ENCLOSURE 1
PROPOSED TECHNICAL SPECIFICATION REVISIONS
BROWNS FERRY NUCLEAR PLANT UNIT 3
(TVA BFNP TS 195)

Description and Justification of Changes - TVA BFNP TS 195 (TVA Browns Ferry Nuclear Plant Unit 3 Technical Specifications)

Figure 3.5.K-1

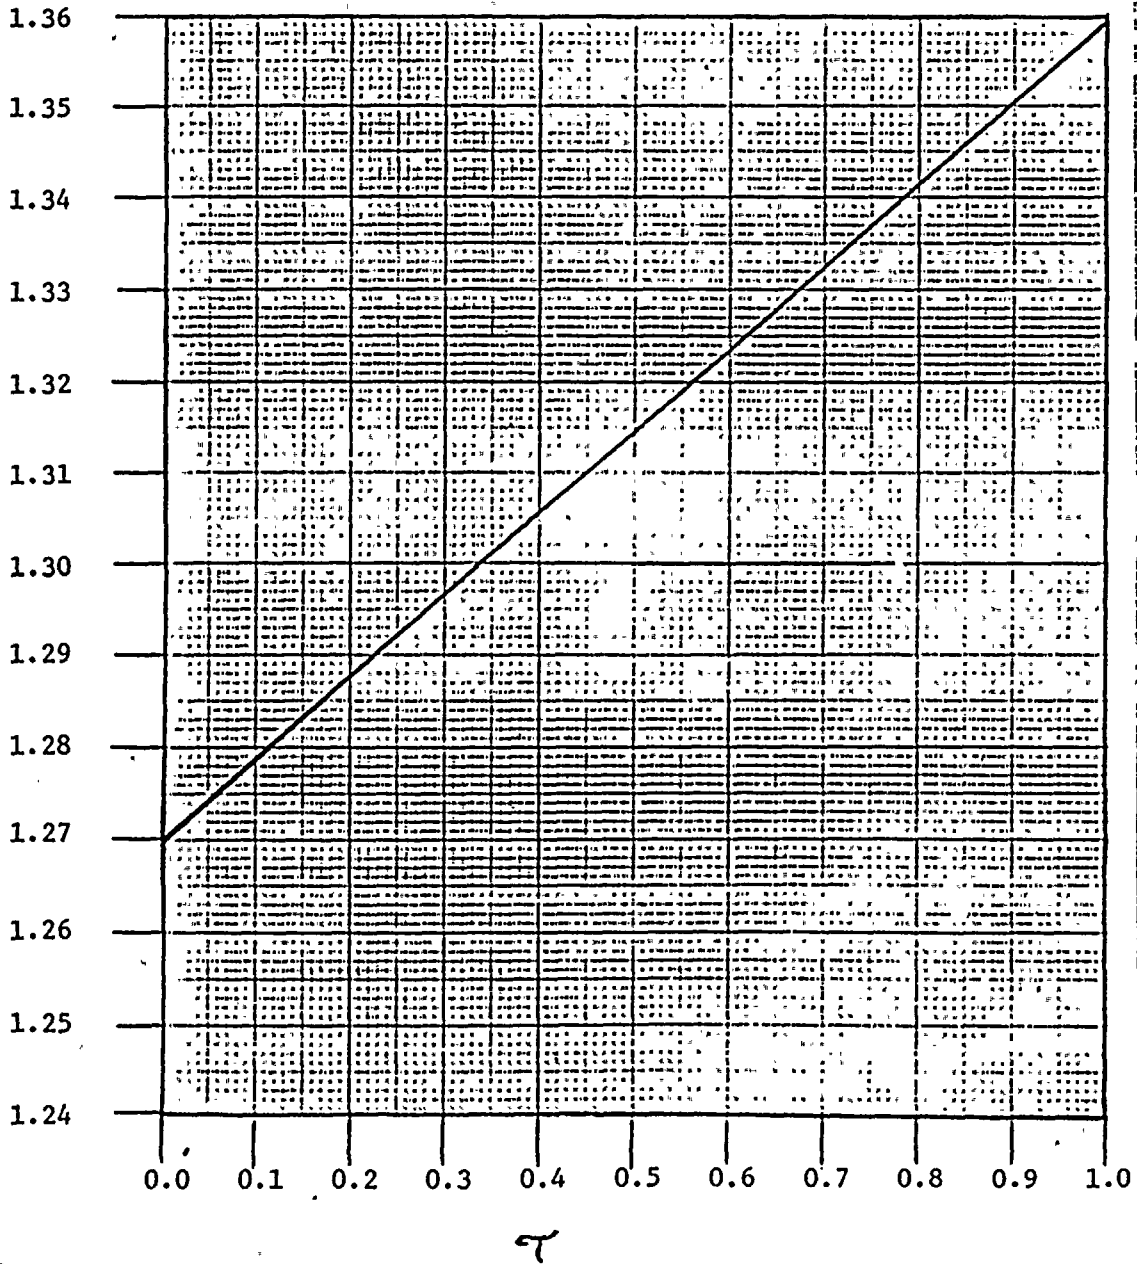
Pages viii and 183c - Figure 3.5.K-1 for M CPR limits was updated to reflect the limits for cycle 6 operations. The table of contents was revised to reflect the new page number.
